Application No.: 10/803,203 Confirmation No.: 5841
First Named Inventor: Bulucea, Constantin Filing Date: 17 March 2004
Group Art Unit: 2826 Examiner: Quach, T. N.
Atty. Docket No.: NS-5737 US
Title: Configuration and Fabrication of Semiconductor Structure Having
N-channel Channel-junction Field-effect Transistor
Assignee(s): National Semiconductor Corporation

AMENDMENT TO DRAWINGS UNDER 37 CFR 1.312

Fig. 12g

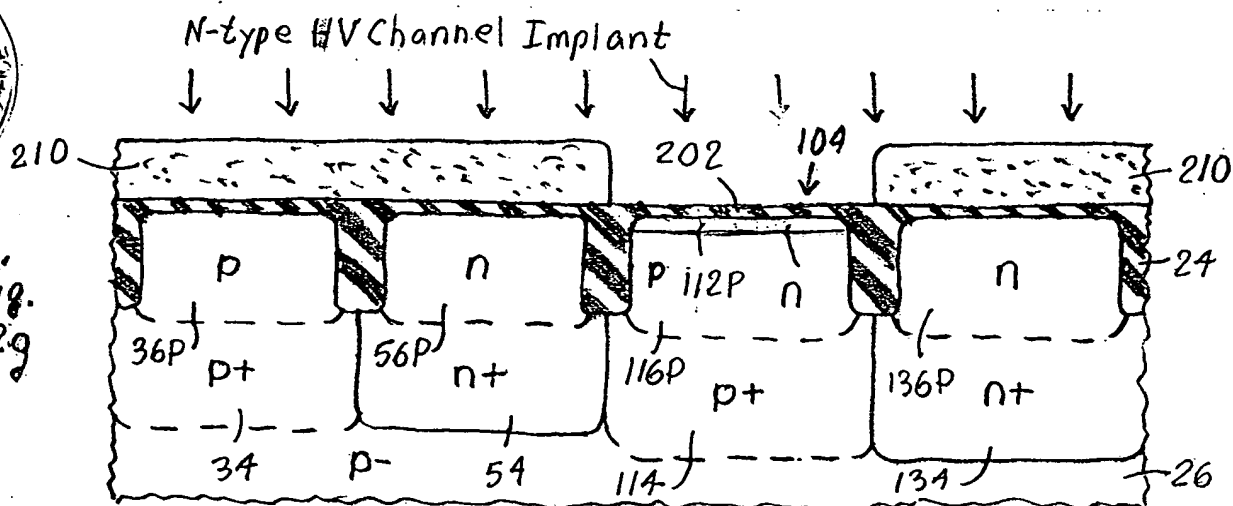
In Fig. 12g, the label "p" should be added to region 116P.

a. Region 116P in Fig. 12g be labeled "p" in conformity with (i) the sentence in paragraph 173 of the specification that "A moderately doped precursor upper body-material portion 116P for IGFET 104 is defined by ion implanting a species of the p-type HV APT dopant, at a moderate dosage through the uncovered section of screen oxide 202 and into epitaxial layer 26P" and (ii) the description of upper body-material portion 116P as a "p" region in the first sentence of paragraph 174 of the specification;

Fig. 12w.2

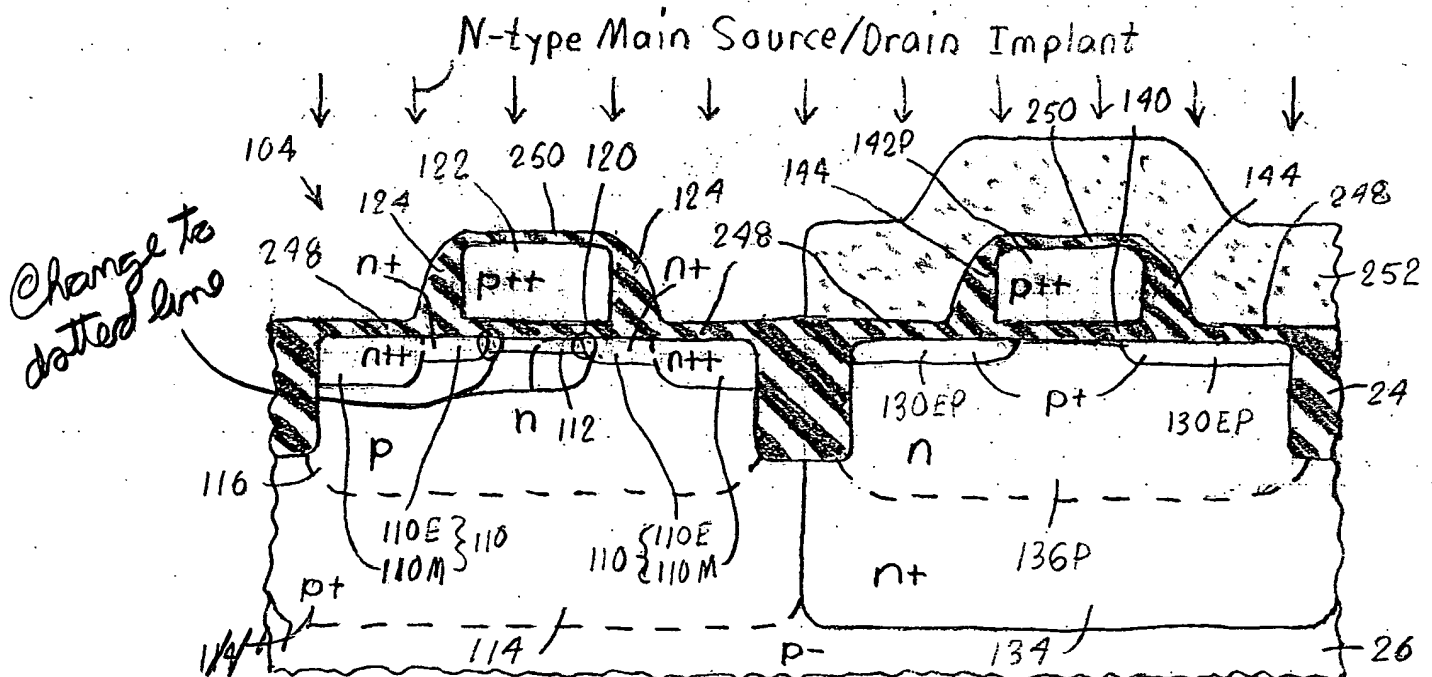
In Fig. 12w2, the label "p" should be added to region 116.

b. Region 116 in Fig. 12w.2 of Fig. "12w" similarly be labeled "p" in conformity with (i) the preceding addition of label "p" to region 116P in Fig. 12g and (ii) the labeling of region 116P in Fig. 12v.2 of immediately preceding Fig. "12v" as "p" and the labeling of region 116 in Fig. 12x.2 of immediately following Fig. "12x" as "p"; and
